PARTS & SERVICE NEWS

REF NO. AA00029

SUBJECT: REPAIR OF PRESSURE SWITCH FOR THE ELECTRONIC CONTROLLED SUSPENSION SYSTEM (ECSS) ACCUMULATOR

PURPOSE: To introduce modification procedures to repair broken pressure switch for the ECSS accumulator.

Fig. 1 Pressure Switch

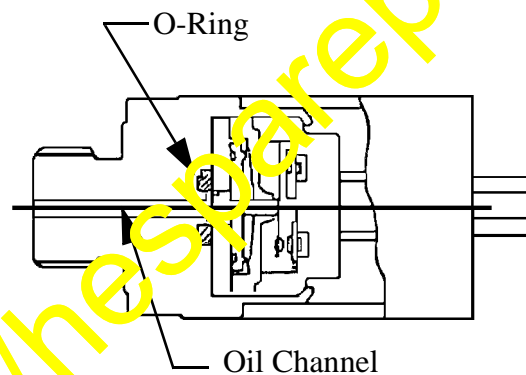
The pressure switch is to be replaced with an improved part with the increased proof pressure (with reduced pressure receiving load).

The material of the o-ring has been changed: Silicon (Hs70) > NBR (Hs90)
 The size of the o-ring has been changed: Inner diameter 10.8 > 6.8
 The diameter of the channel has been changed: Inner diameter 2.5 > 2.0

Fig. 2 WA500-5 ECSS Accumulator

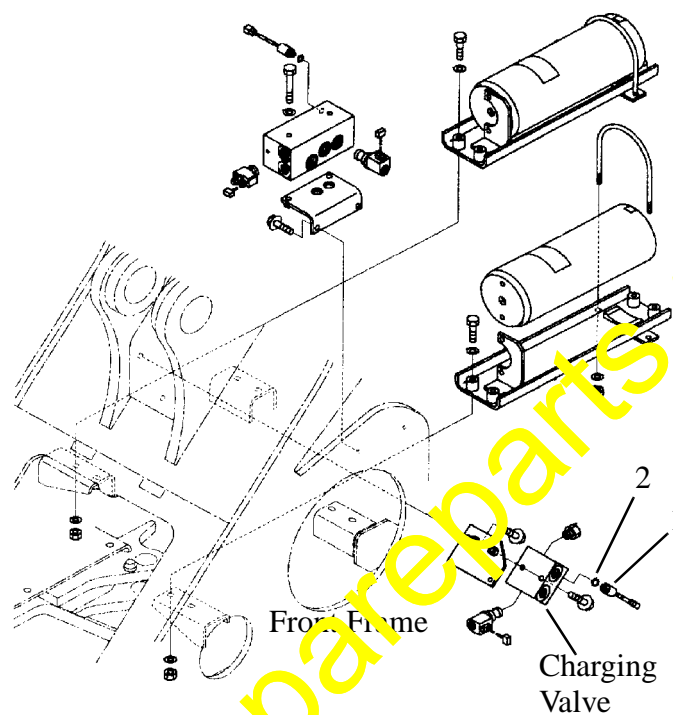
Replace the pressure switch for the ECSS accumulator with the improved part.

Tightening torque: 19.6 - 24.5 N-m (14.5 - 18.1 ft. lb.)
